Service Bulletin No. 3014

MODEL D Series Coaches equipped w/ DDC S60 Pre-2007 Engine	TYPE Product Improvement	SECTION/GROUP 7--Electrical	DATE July 21, 2009
SUBJECT STARTER CABLE CHAFFING			
CONDITIONS Parts may be purchased from MCI Service Parts, Louisville, Kentucky or from MCI Service Parts, Newcastle, Ontario.

Effective with unit number 57956, MCI made design changes to the starter cable installation on coaches equipped with a Detroit Diesel S60 Pre-2007 engine. The new starter cable installation will reduce the potential for cable damage or chafing due to contact with brackets and / or movement within the cable clamps.

Figure 1.

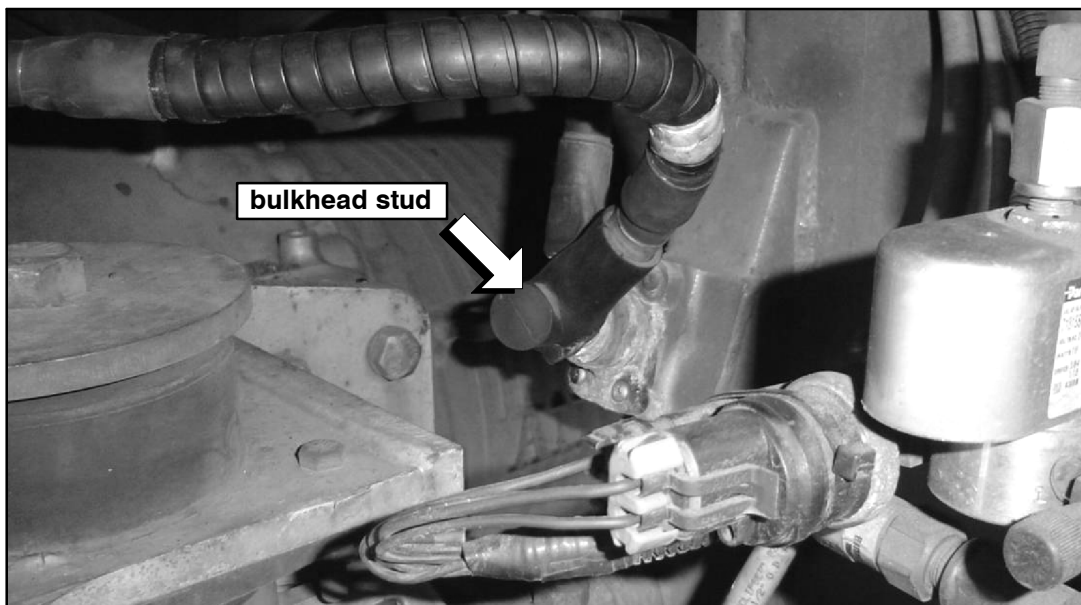
4. Locate the cable terminal stud on the forward wall of the curbside, rear side service compartment (refer to Figure 1). Remove and retain the nut. Remove the starter cable from the bulkhead stud.

8. Place the starter cable on the bulkhead stud. Secure the cable terminal stud using nut remove in Step 4 (refer to Figure 1). Torque to 20 to 25 ft. lbs.
9. Close the engine compartment and curbside, rear side service compartment doors.

Figure 2.

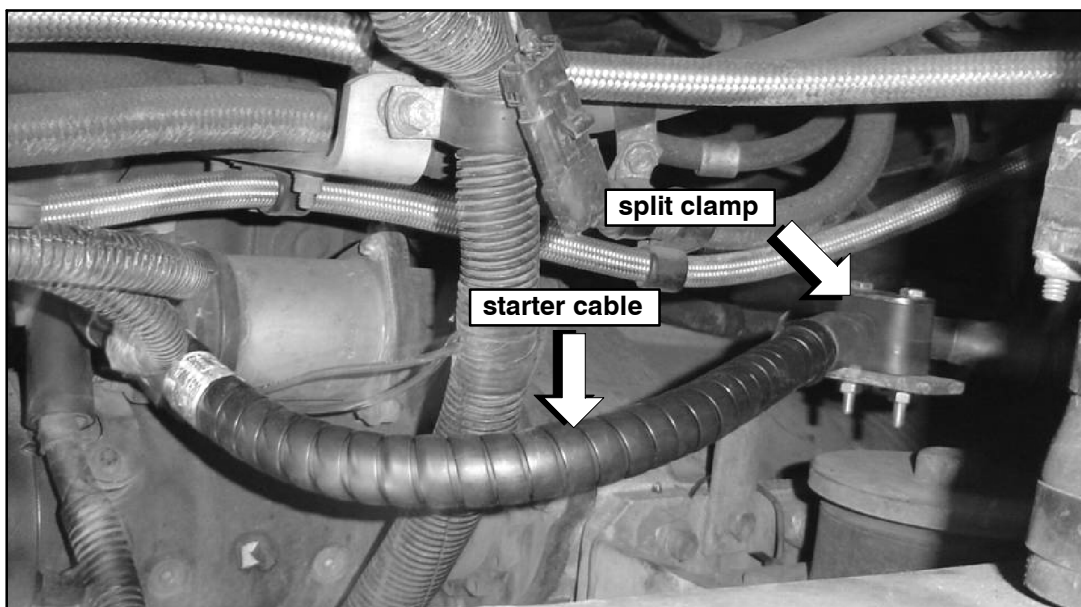
5. Follow the routing of the starter cable along the curbside of the DDC S60 engine. Remove and discard the starter cable.
6. Using the mounting bolts removed in Step 3. , install the new starter cable, p/n 07-09-1520 onto the starter 24V DC battery stud. Torque to 20 to 25 ft. lbs.
7. Replace the existing split clamp with new split clamp, p/n 19-04-0419 (refer to Figure 2). Using bolts 19-1-1072, washers 19-2-289, lock washers 19-2-27 and nuts 19-3-32, secure the starter cable. Torque to 9 ft. lbs.
